Detroit
Edison

September 9, 1982
EF2 - 59,281

Subject: Mark I Containment
Submittal of Additional Information

Figure 1-1 - Ring Beam Cross-Section at Segment 7 for Acceleration Drag Volume Calculation

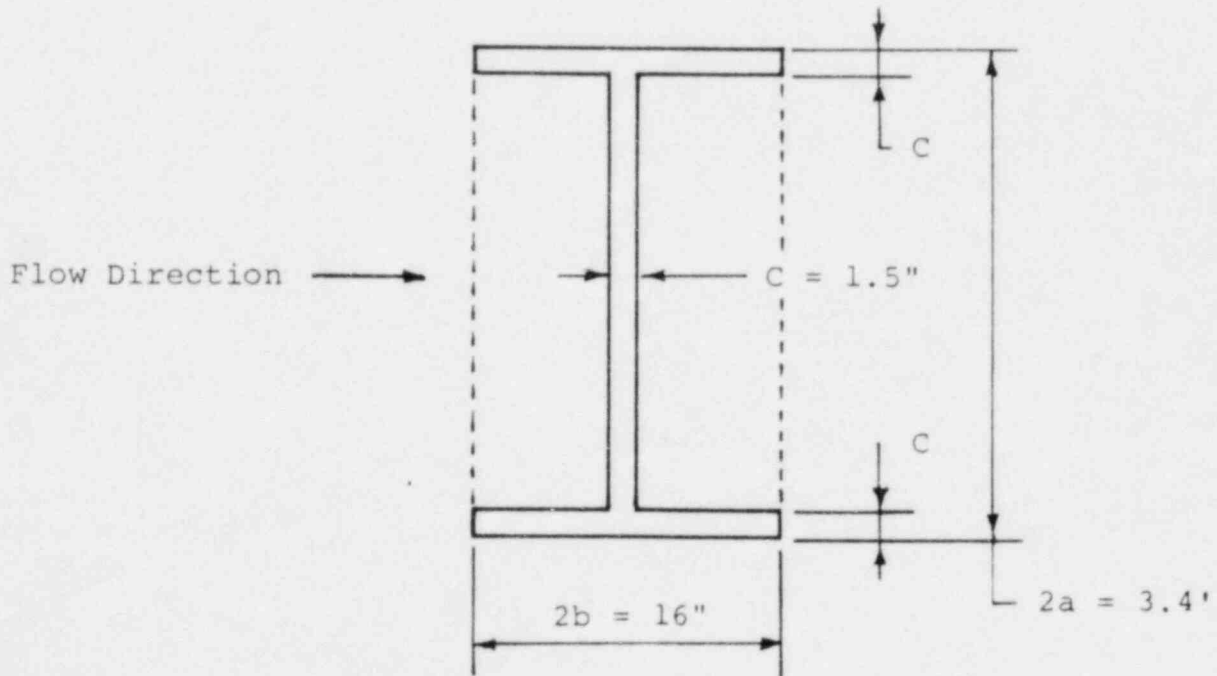
Published acceleration drag volumes were used to determine the drag loads on sharp cornered submerged structures instead of the equivalent cylinder procedure specified in the acceptance criteria. Provide a list of structures which were treated in this manner. For the ring beam, provide specific dimensions of the structure, as well as the local acceleration and velocity for the post-chug loading condition. A copy of K. T. Patton's MS thesis from the University of Rhode Island (1965) would be useful in resolving this issue if it is available.

For submerged structure loads, the contribution due to velocity drag is negligible compared to acceleration drag. Attached Figure 1-1 shows the cross-section of the ring beam at segment 7 used for calculating the acceleration drag volume. For the flow direction normal to the web, the beam is idealized as a rectangular cross-section as shown by the dotted lines in Figure 1-1. From the LDR Table 4.3.4-1 the acceleration drag volume, V , for a rectangular cross-section is:

As discussed earlier, the acceleration drag volume for various segments of the ring beam for the flow direction normal to the web has been calculated by idealizing the I-section by a rectangular section. In the equation of acceleration drag volume, the

area of the cross-section was conservatively added as the area of the rectangular cross-section rather than the actual I-section. Overall, the submerged structure loads in the PUAR have been calculated conservatively.
